**New grinder**

**IMPLEMENTATION DATE:** 2013-09 (IT0335/2013)

**MODELS:** INT/A/RU/SKA/EST/TR/AU/NZ/DE/BR/CH/GB/AT/DE/ZA/SKA/CN - 220/240

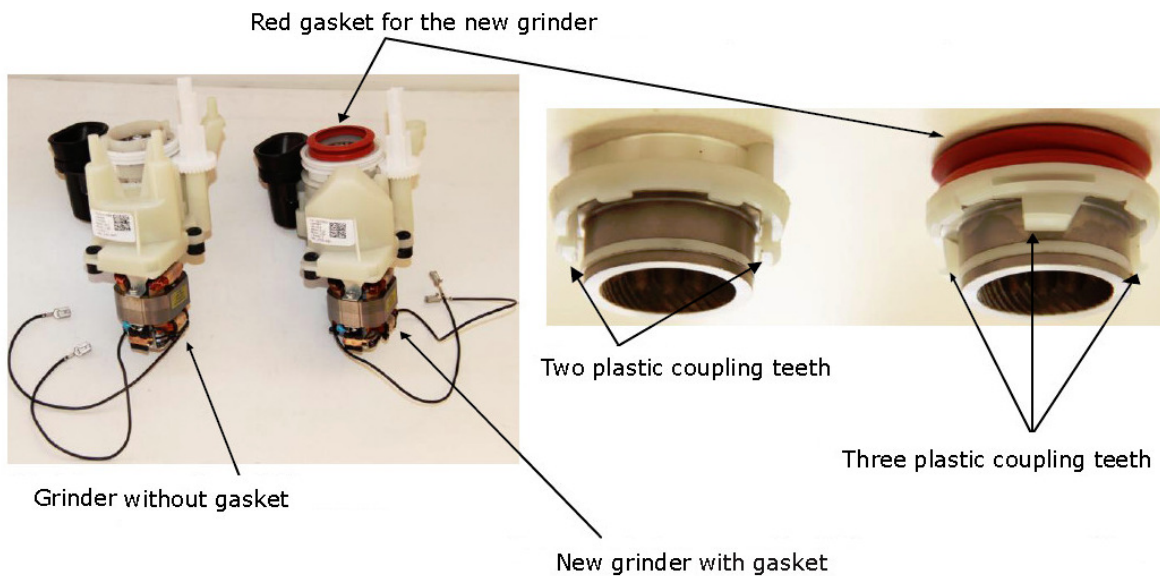
**DESCRIPTION:** Since January of 2013, a new grinder is fitted in the models described.

As You can observe in the pictures attached, new grinder has, among other things, a red gasket in the upper position (noticeable at first sight when the grinder is fitted in the appliance), absent from the previous one, besides three plastic coupling teeth (instead of two of the previous version) used to assembly the external mill to the grinder.

There is **no interchangeability** between the two versions of grinder.

In case of replacing the grinder, please, order p/n **4055260535** if the unit you find in the appliance (the unit to be replaced) is the newer one (with the red gasket) or order p/n **4071393716** if the grinder to be assisted has not the characteristics described (for ex. you don't find the red gasket).
